## SUBMISSION ON THE CANBERRA HOSPITAL MASTER PLAN

Public Transport Association of Canberra

The Public Transport Association of Canberra (PTCBR) welcomes the opportunity to provide input to the proposed master plan for the Canberra Hospital precinct. This submission provides our views in the context of the *Canberra Hospital Expansion* pre-development application plans as presented on the ACT Government's [project website](#).

Figure 1: Canberra Hospital SPIRE Project - Access and Entry Review Study (November 2019)

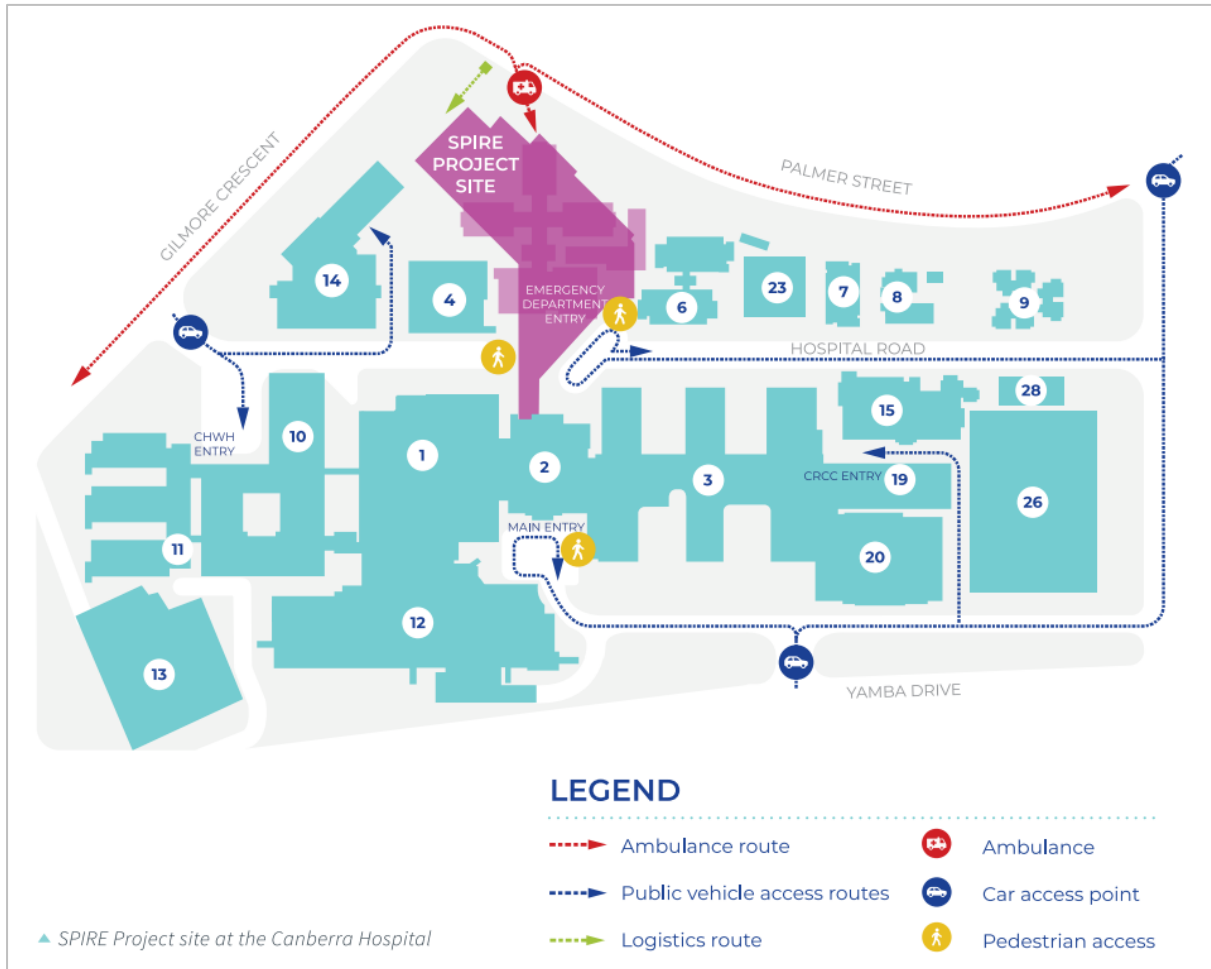
Prior to its closure in May 2020, Hospital Road functioned as the key public transport access point for people wishing to visit the hospital. As illustrated in **Figures 1 and 2**, it is evident that the *Canberra Hospital Expansion* will result in the permanent closure of Hospital Road as a public transport access route.

As it currently stands, the ['temporary' re-routing](#) of the R6 bus is highly unsatisfactory. The alternative Bateson Road stop is 350 metres from the main hospital entrance, with the Yamba Drive stop being almost as far and requires passengers to cross a high-speed arterial road and negotiate a significant change in elevation to access the hospital.

As part of the master planning process, PTCBR strongly urges the ACT Government to develop a comprehensive transport plan for the Canberra Hospital precinct. This plan should identify and safeguard a long-term public transport route capable of supporting a frequent, high-capacity rapid service that provides stops close to the main clinical buildings. With the closure of Hospital Road, Palmer Street and Gilmore Crescent may prove to be a more suitable route for these purposes.
